**SECTION 96(1A) MODIFICATION APPLICATION
SICEEP, DARLING SQUARE, NORTH-EAST PLOT (SSD 6626)**

On behalf of Lendlease (Haymarket) Pty Ltd (Lendlease) we hereby submit an application pursuant to section 96(1A) of the *Environmental Planning and Assessment Act, 1979* (EP&A Act) to modify Development Consent SSD-6626 relating to the development of the North East Plot of Darling Square which is part of the Sydney International Convention, Exhibition and Entertainment Precinct (SICEEP) at Darling Harbour, Sydney.

Figure 3 – Proposed ground level amendments
Source: Tzannes

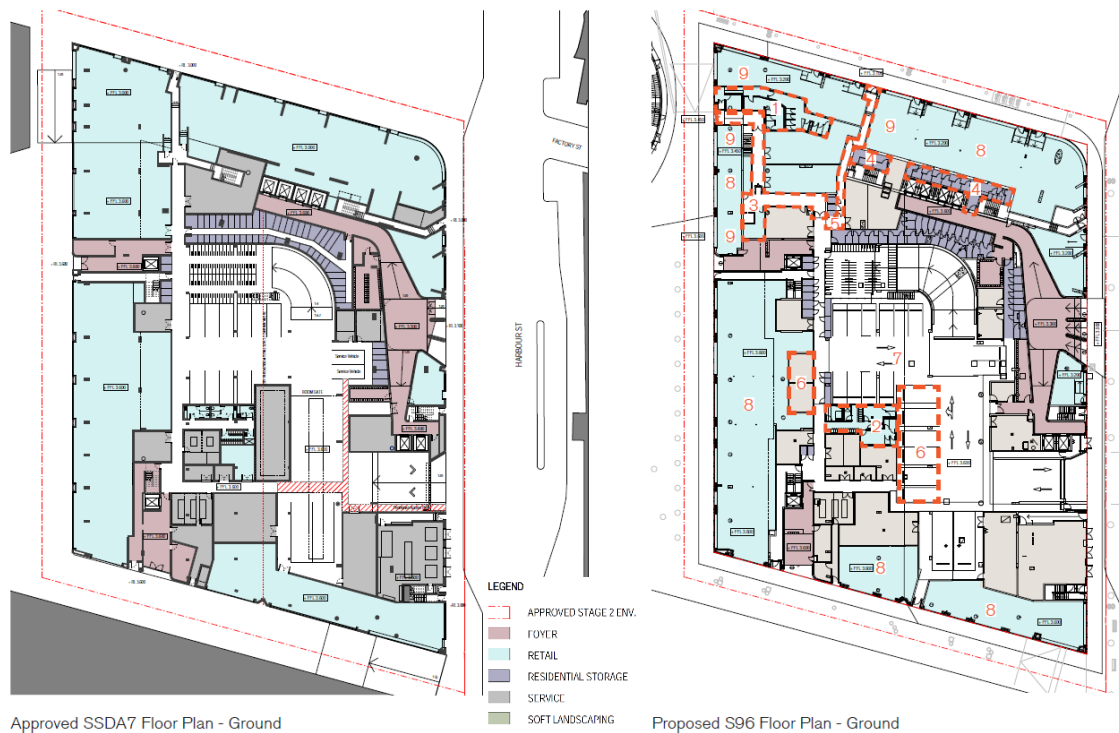
A number of design modifications are proposed to the ground level of the North East Plot. These modifications include:

- provision of public toilets, comprising male toilets and female toilets to service users of The Square and retail visitors;
- refinement of back of house facilities for the retail tenancies and North Plot to accommodate general storage;
- addition of six (6) new service bays and corridor access to these bays to service both the North Plot and North East Plot;
- provision of additional storage cage area allocation;
- realignment of egress stair;
- relocation of fire tank;
- general refinements to internal configuration/layouts resulting from design development;
- reduction of retail Gross Floor Area (GFA) from 2,050sqm to 1,986sqm; and
- public domain and retail levels revised in accordance with the flood mitigation strategy.

Figure 3 illustrates the proposed amendments to the ground level.

Figure 5 – Proposed Level 34-37 study changes and façade amendments
 Source: Tzannes

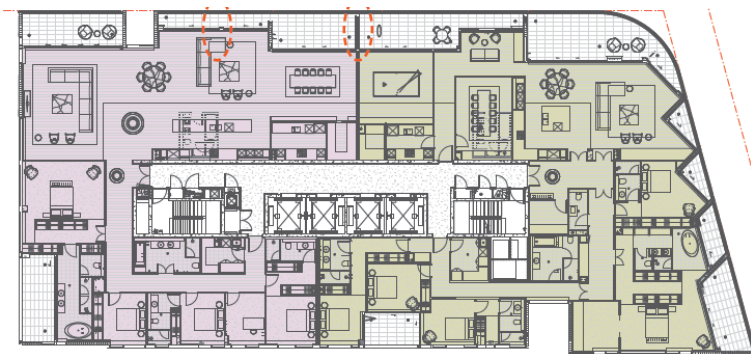
On levels 34-37 of Building NE3, a number of plant rooms are proposed to be converted to study areas for the adjacent apartments. The louvres for these spaces on the façade have been replaced with glazing, reflecting the use within the building (refer to **Figure 5**). These changes result in a minor increase in residential GFA.

Furthermore, the redundant louvres to the roof plant have been replaced with opaque glass, ensuring a consistent façade glazing system and appearance. This glazing has been extended to Levels 38-40 to maintain consistency (refer to **Figure 5**). Glazing has also been extended to Levels 38-40 on the western façade to address internal planning refinements.

Figure 7 – Harbour Street lobby entrance element changes
 Source: Tzannes

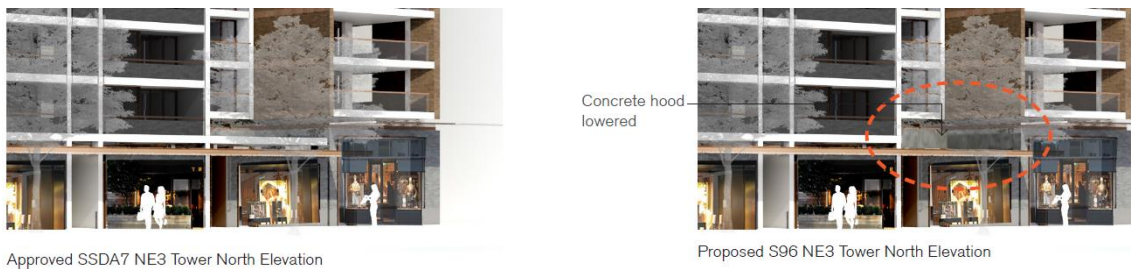
- the detailing of the lobby entrance element along Harbour Street is proposed to be refined, with the simplification of the awning at ground level and amendments to columns, brick dimensions and concrete thickness (refer to **Figure 7**);
- additional brick columns have been added to the Building NE2 ground floor elevation;
- additional brick piers and brick upstands have been added to the retail frontages along Factory Lane, Harbour Street and Little Hay, providing an enhanced interface and managing any potential flooding impacts; and
- vertical aluminium screens have been added to windows of habitable rooms along the southern façade on podium levels 1 to 5, consistent with the approach to satisfying Condition C3 of the South East Plot Development Consent.
